Addendum No. 01

Subject: John Marshall Elementary School – Relighting Project
SDP Contract No. B-028 (C) of 2017/18

Location: John Marshall Elementary School
1500 Griscom Street,
Philadelphia, Pennsylvania 19124

DRAWING NO.
ED100

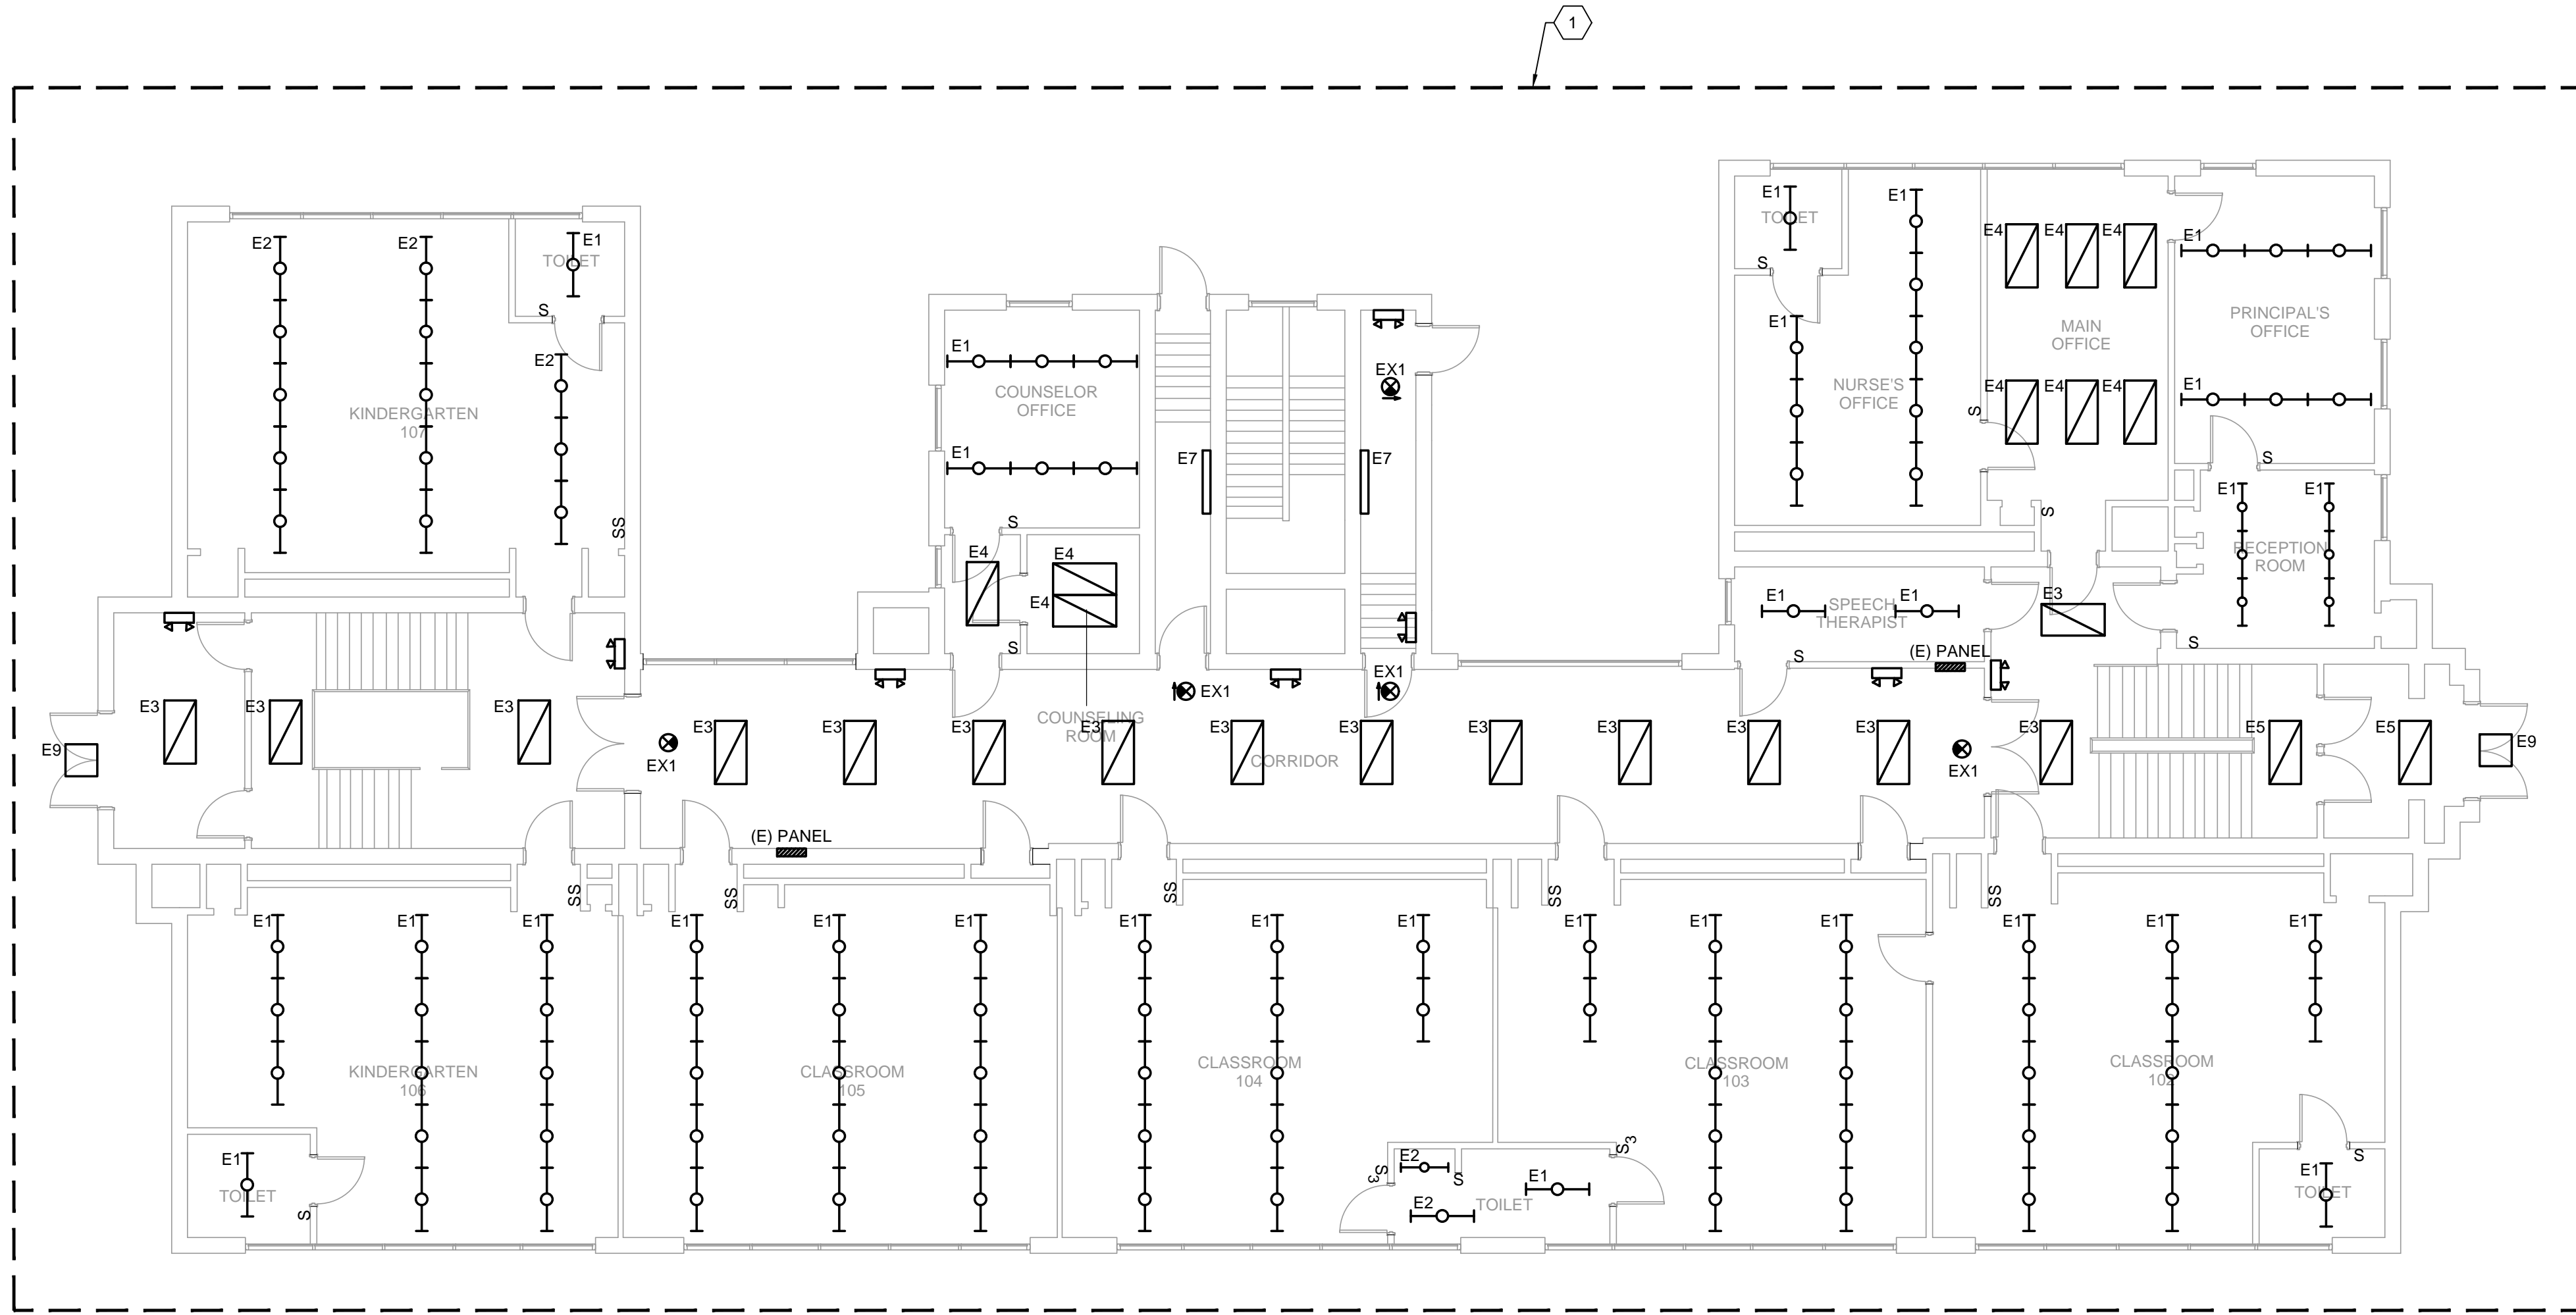
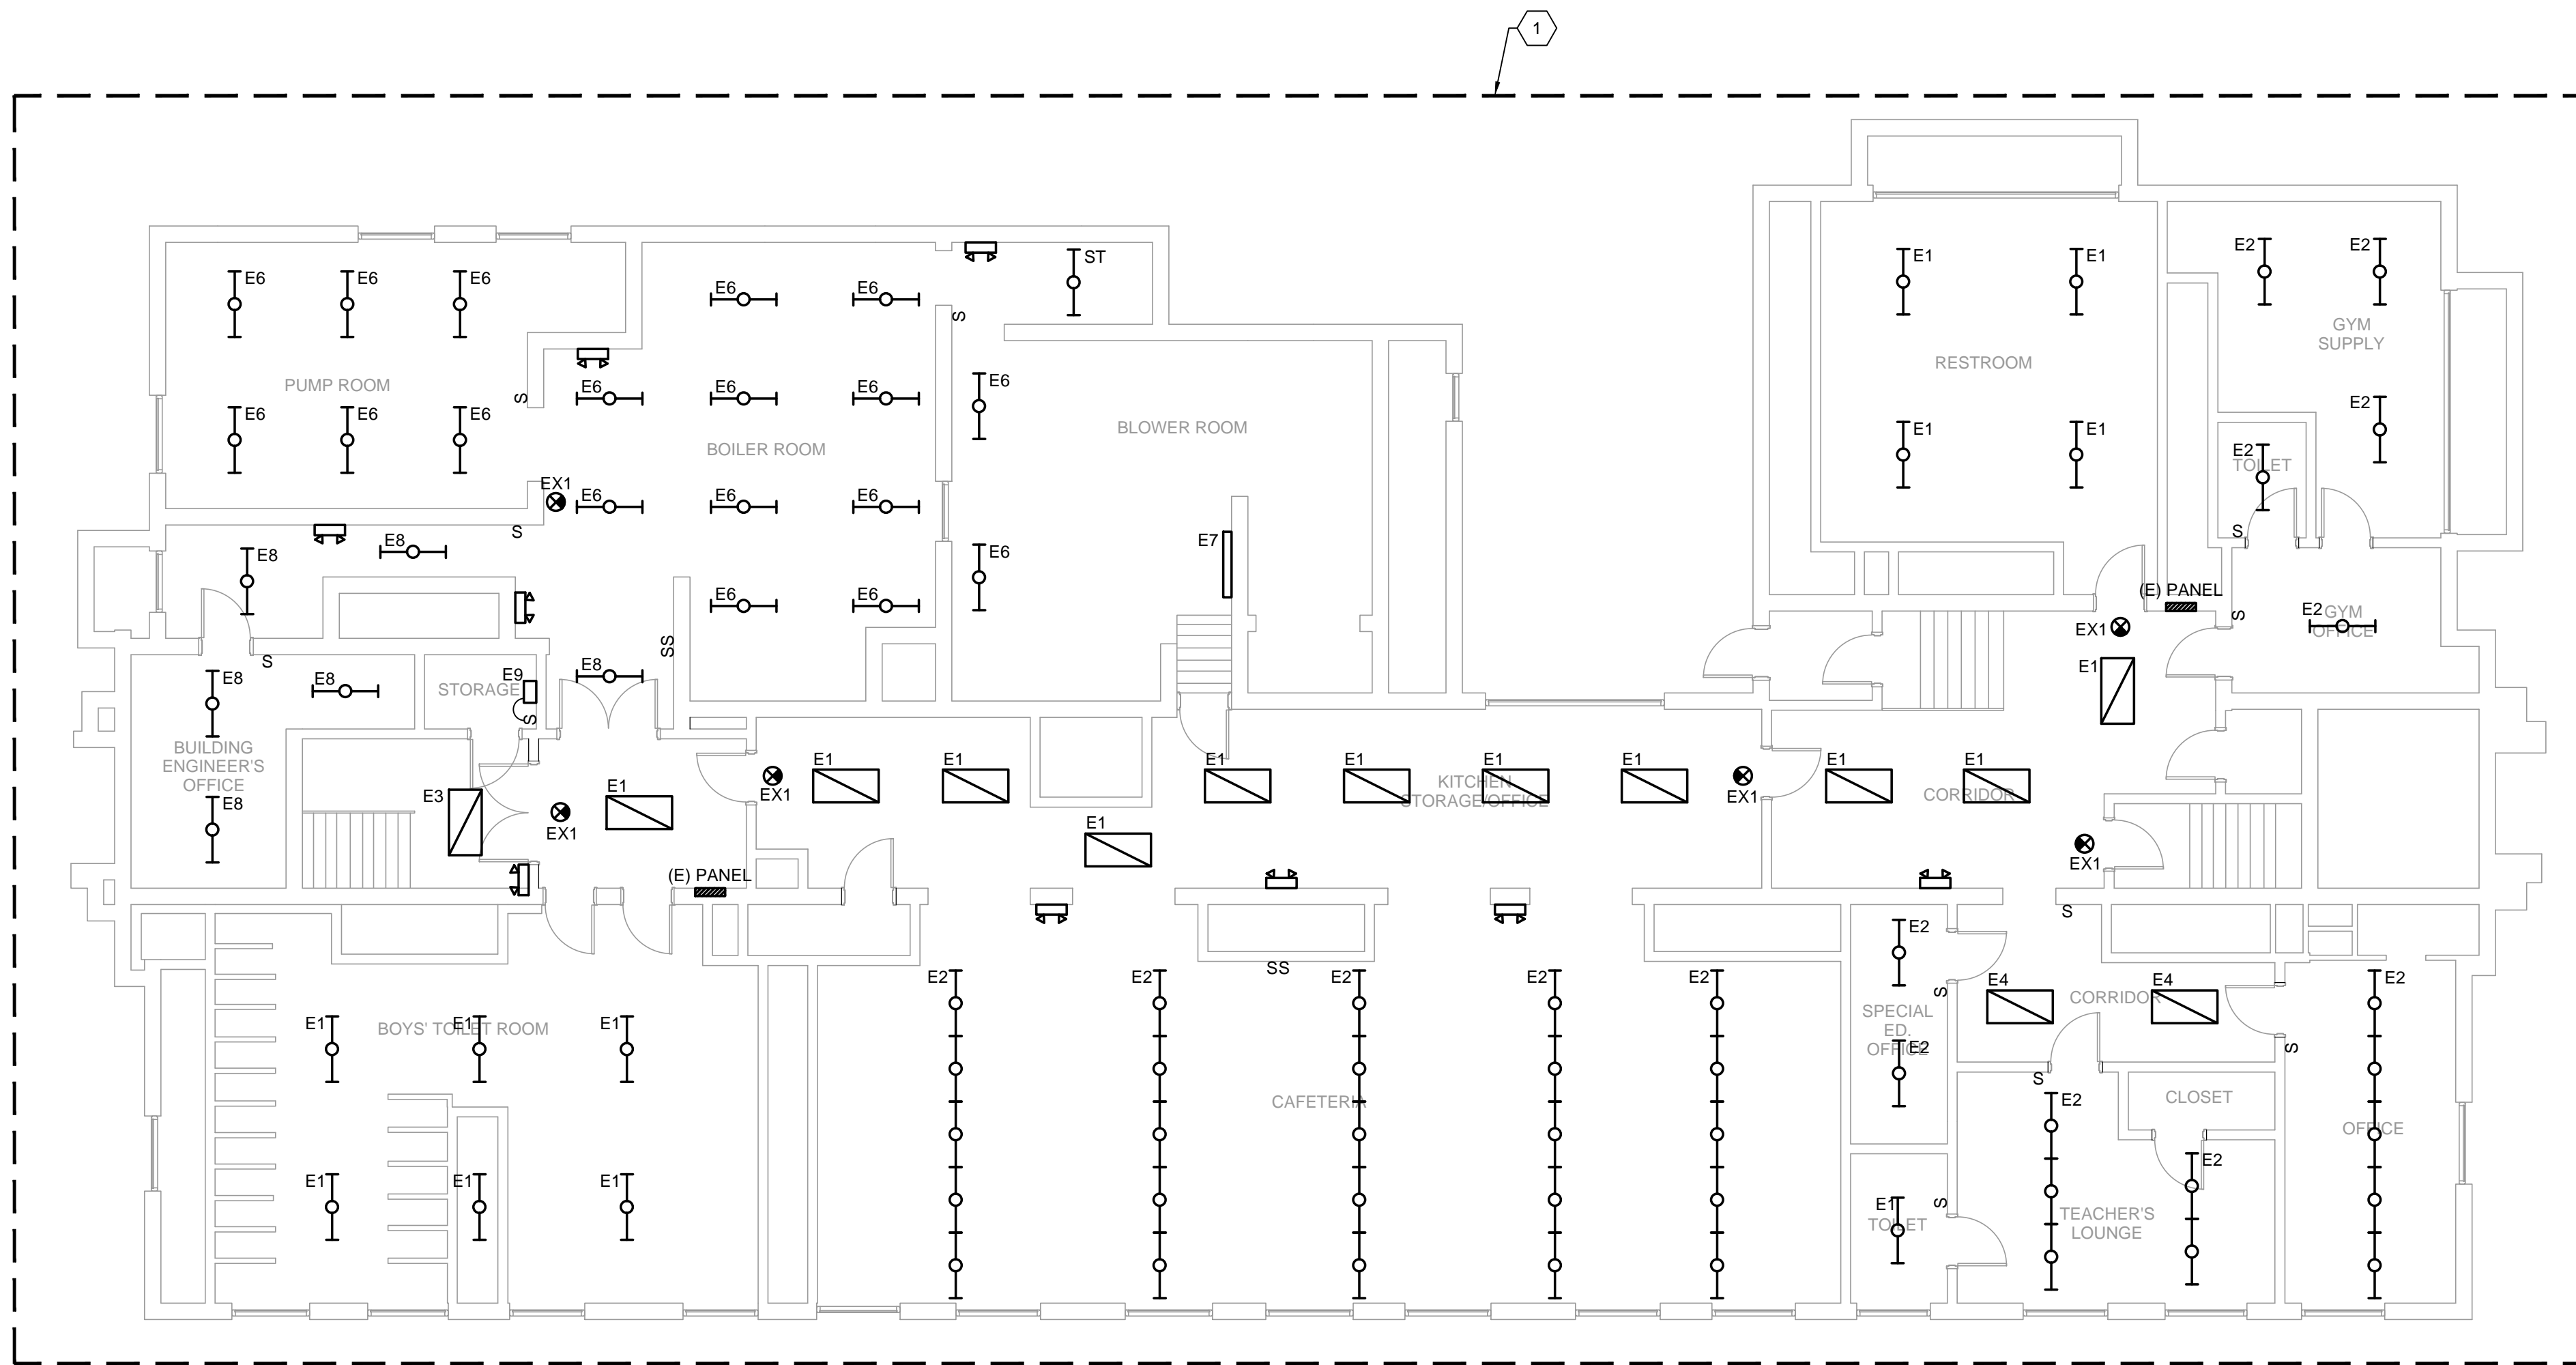
ED100 – Revised Keynote #1.
ED101 – Revised Keynote #1.
E501 – Added detail #5.
E601 – Revised light fixture schedule.

Question#2: Is it clear in drawings that the existing wiremold raceways need to be replaced as part of the re-wiring?

Question #3: ED100 Keynote 1 “Trace all circuits & label for reuse for new light fixtures”. E100 Keynote 1 “Provide new conduit & wiring for new light fixtures & controls.

These two notes seem to contradict one another.

- a. Do we provide new circuit wiring from the existing panels to each classroom? How many circuit to each room?
- b. There seems to be no concealed conduit to existing lights or switches, all wiring seems to be in surface mounted wiremold. Should we bid to replace all wiremold with new conduit and wiring?
- c. Corridor lights are switch on off at night from the breakers in the existing panels. Should we bid to re-wire to existing breakers with additional wiring to feed the new bodine ballast for emergency lights?

Response – The design intent is as follows: Keynote #1 on the demolition drawings have been updated to indicate removal of all accessible surface mounted raceways which includes any wiremold raceway. As noted on the new work drawings General Note H and Keynote #1, is all new lighting circuiting and controls wiring shall be installed in all new surface mounted EMT conduits and wiring within corridors, classrooms and offices, and rigid steel conduit within boiler rooms, mechanical rooms, and electrical rooms. Existing concealed conduits (EMT and RGS type only) which were previously used for the existing lighting circuiting and controls wiring may be reused if the existing conduit has been field inspected by the contractor and is in good condition for the new lighting circuiting and controls wiring. Existing surface mounted wiremold raceway may not be reused, it must be removed and replaced with new EMT or RGS conduit for wiring.

Response to Question 3a. – During the demolition phase, the contractor is responsible to trace all lighting circuits to determine the source panel board and breaker that is serving the lighting within each space. The existing lighting circuit in its entirety (conduit, surface mounted wire mold raceway, and wiring) shall be removed back to the existing source panel board. The existing breaker which was being utilized as a lighting circuit for the old light fixtures within each space shall be reused and new conduit and wiring shall be installed from the existing source panel board to the new light fixtures and control within each space.

Response to Question 3b. – The design intent is for all existing surface mounted conduit and raceway (wiremold) is to be removed and replace with all new surface mounted conduit (Type EMT and RGS) and copper wiring from the source panel board to each light fixture and controls device.

- 1 DISCONNECT AND REMOVE ALL LIGHT FIXTURES AND SWITCHING CONTROLS. REMOVE ALL ACCESSIBLE SURFACE MOUNTED TRAYS AND WIRING BACK TO SOURCE PANEL BOARD OR NEXT ACTIVE JUNCTION BOX. FOR ALL CONCEALED CONDUIT/WIRING WITHIN WALLS, SLAB, OR CEILING, WIRING SHALL BE REMOVED. CONDUIT SHALL BE CUT AND CAPPED AIR/WATER TIGHT. CONTRACTOR SHALL CIRCUIT TRACE ALL LIGHTING CIRCUITS AND LABEL EXISTING LIGHTING CIRCUIT FOR REUSE FOR NEW LIGHT FIXTURES.
